## HISTORIC AND DESIGN REVIEW COMMISSION

October 20, 2021

**HDRC CASE NO:** 2021-505  
**ADDRESS:** 515 MUNCEY  
**LEGAL DESCRIPTION:** NCB 1368 BLK 5 LOT 11  
**ZONING:** R-6, H  
**CITY COUNCIL DIST.:** 2  
**DISTRICT:** Dignowity Hill Historic District  
**APPLICANT:** Michelle Reyes  
**OWNER:** Michelle Reyes  
**TYPE OF WORK:** Exterior alterations, addition, window replacement, fenestration modifications, driveway modifications  
**APPLICATION RECEIVED:** September 30, 2021  
**60-DAY REVIEW:** Not applicable due to City Council Emergency Orders  
**CASE MANAGER:** Edward Hall

SITE PLAN

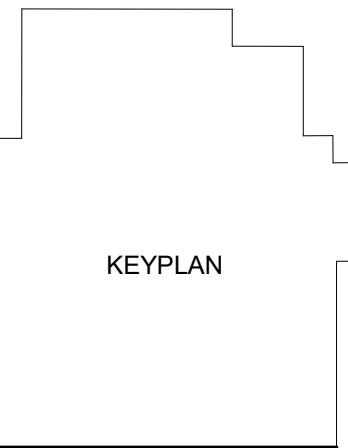
- l. REAR PORCH – The applicant has noted on the proposed site plan the construction of a rear, uncovered porch that extends to the side of the proposed addition. The applicant has not submitted construction documents for this item. Staff finds that a rear, uncovered porch may be appropriate; however, its footprint should be consistent with that of the rear addition and should not feature a width that exceeds that of the historic structure's.

- m. DRIVEWAY – The applicant has proposed to extend the existing, gravel driveway further to the rear of the site. Staff finds this proposal to be appropriate provided that the driveway does not exceed ten (10) feet in width.

- 7. Staff does not recommend approval of item #7, the construction of a rear porch based on finding l. A rear, uncovered porch may be appropriate; however, its footprint should be consistent with that of the rear addition and should not feature a width that exceeds that of the historic structure's. Construction documents for any rear porch should be submitted for review and approval.

- 8. Staff recommends approval of item #8, the extension of the existing, gravel driveway with the stipulation that it does not exceed ten (10) feet in width.

EXISTING  
ELEVATIONS

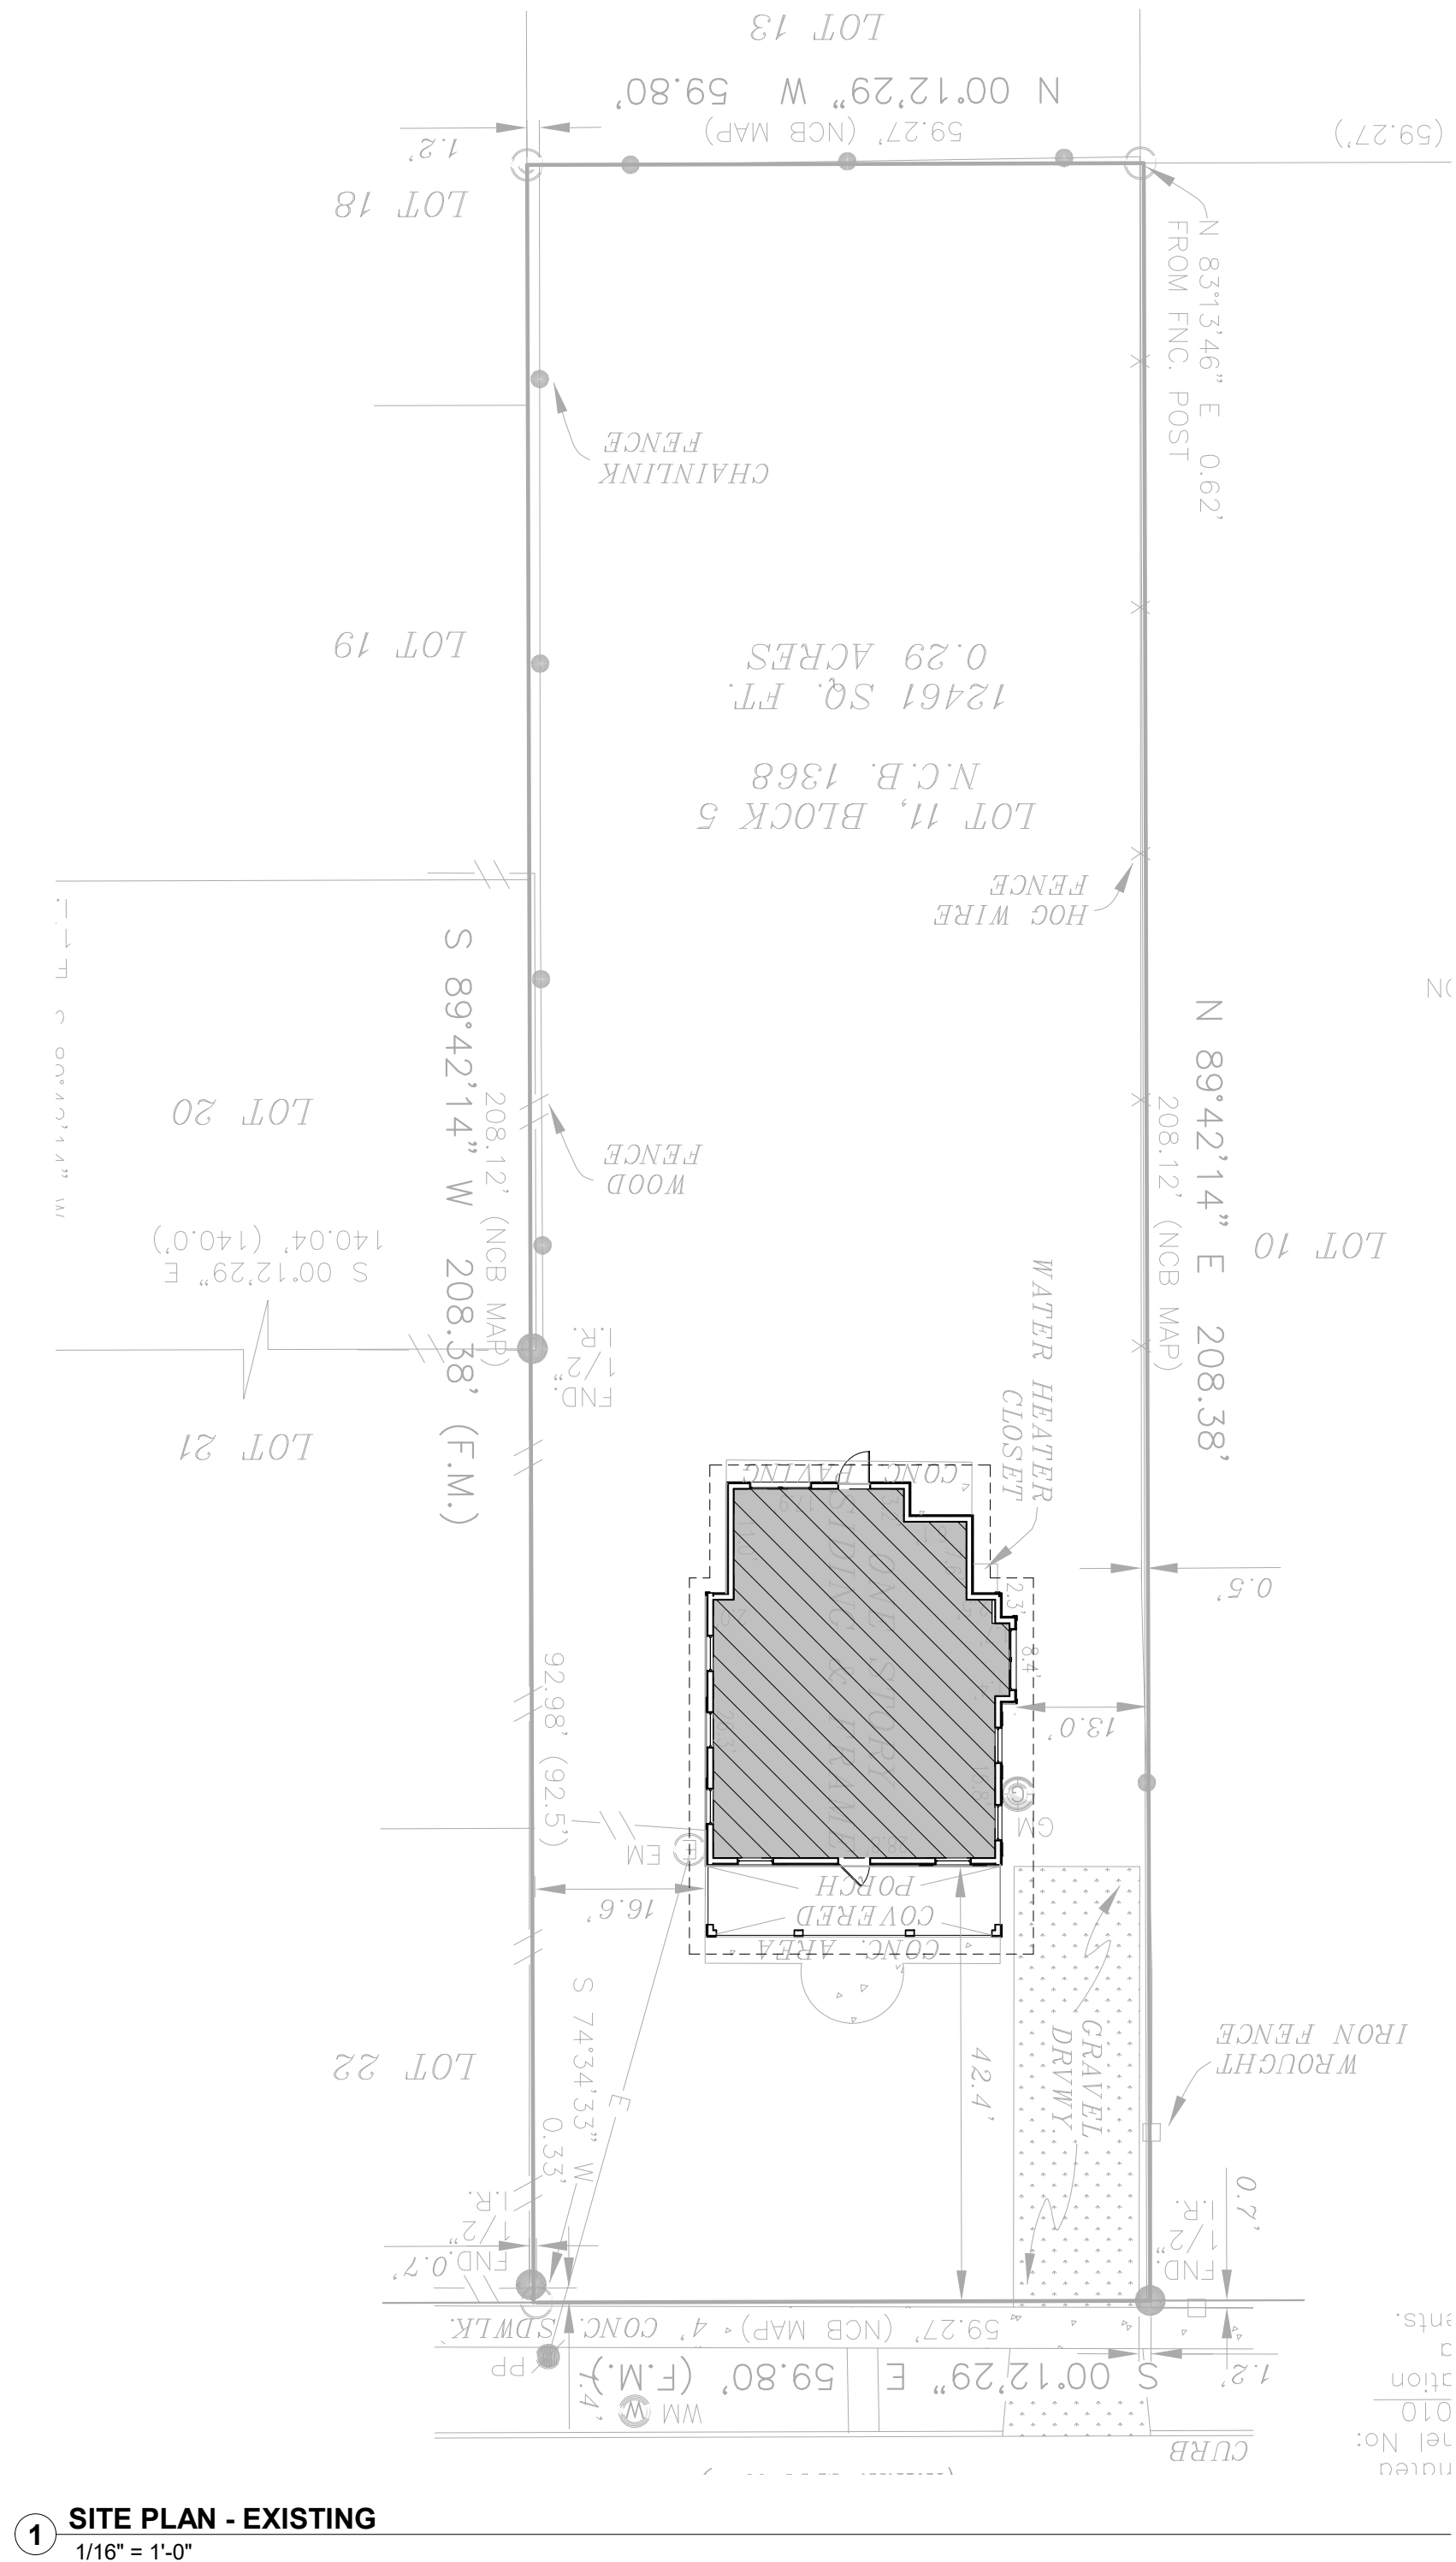
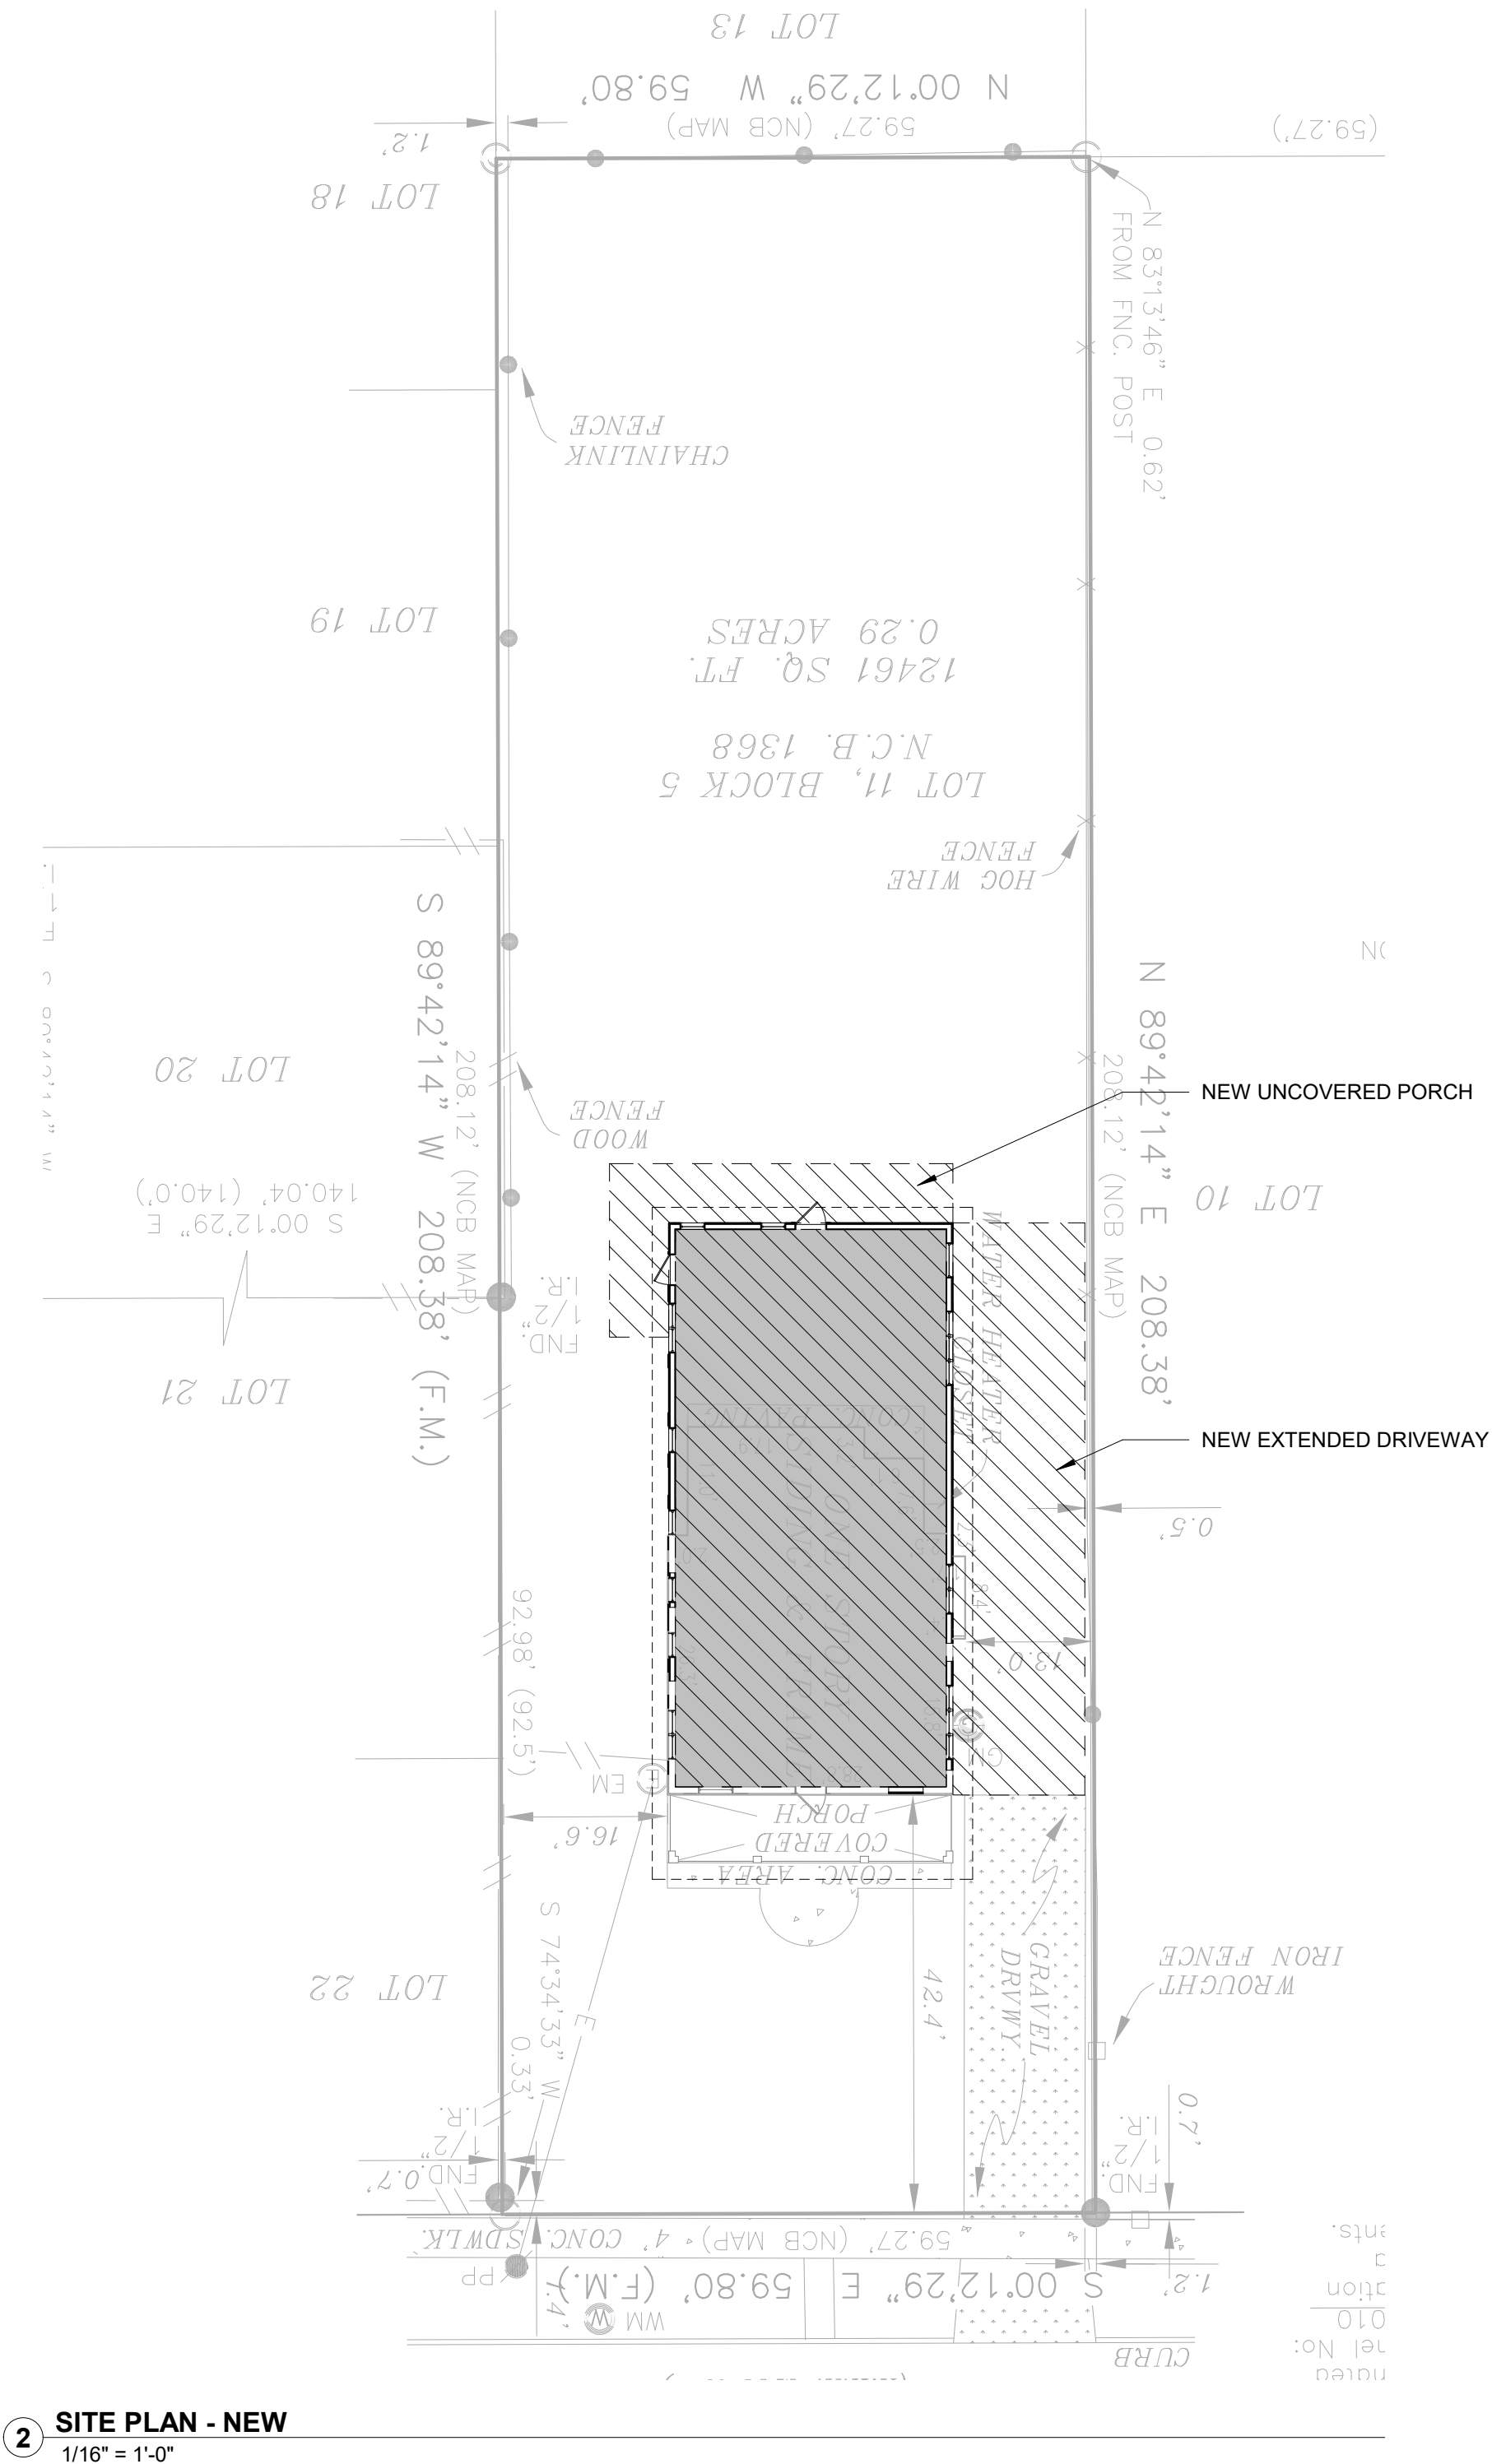
- c. SIDING – The applicant has proposed to replace the original wood siding with 117 profile siding. While the original wood siding had been covered by vinyl siding, portions that remain appear to be in good condition. Per the Guidelines for Exterior Maintenance and Alterations 1.B.i. materials that are in good condition should not be removed and should be repaired in place. Staff finds the replacement of the original siding to be neither consistent with the Guidelines not appropriate.

- d. WINDOW REPLACEMENT – The applicant has proposed to replace the existing wood windows with new windows. The applicant has not specified a specific window profile or material at this time. Pre-violation photos note one over one wood windows. Per the Guidelines for Exterior Maintenance and Alterations 6. A.iii. historic windows should be preserved. During staff’s site visit on September 2, 2021, all existing wood windows had been removed and discarded. Staff finds that salvaged or custom fabricated, one over one wood windows should be installed to match the original in size and profile.

- f. FENESTRATION MODIFICATIONS – The applicant has proposed fenestration modifications including the removal of a window on the front façade, and modifications to openings on the sides (north and south facades), including the expansion, shifting and removal of original window openings. The Guidelines for Exterior Maintenance and Alterations 6.A.i. notes that existing window and door openings should be preserved. Staff finds the applicant’s request to modify the original window openings to be inconsistent with the Guidelines.

- g. FRONT DOOR REPOSITIONING – The applicant has proposed to reposition the front door to be centered on the front façade. The existing door opening is off-centered, positioned to the right of the center of the structure. The Guidelines for Exterior Maintenance and Alterations 6.A.i. notes that existing window and door openings should be preserved. Staff finds the applicant’s request to modify the original window openings to be inconsistent with the Guidelines. Staff has found no evidence that this door opening is not the original. Staff finds the proposal to reposition the door to be inconsistent with the Guidelines.

- 1. Staff does not recommend approval of item #1, the replacement of the original wood siding, based on finding c. Since all original siding has been removed and discarded, staff recommends that siding that features a matching profile be installed.

- 2. Staff does not recommend approval of item #2, the replacement of all original wood windows, based on finding d. Since all original windows have been discarded, staff recommends that salvaged or custom fabricated, one over one wood windows be installed to match the original in size and profile.

- 4. Staff does not recommend approval of item #4, fenestration modifications. Staff recommends that all original window openings should be restored and that no new openings should be introduced to the historic structure, based on finding f.

- 5. Staff does not recommend approval of item #5, front door repositioning, based on finding g. Staff recommends that the existing door opening be preserved.
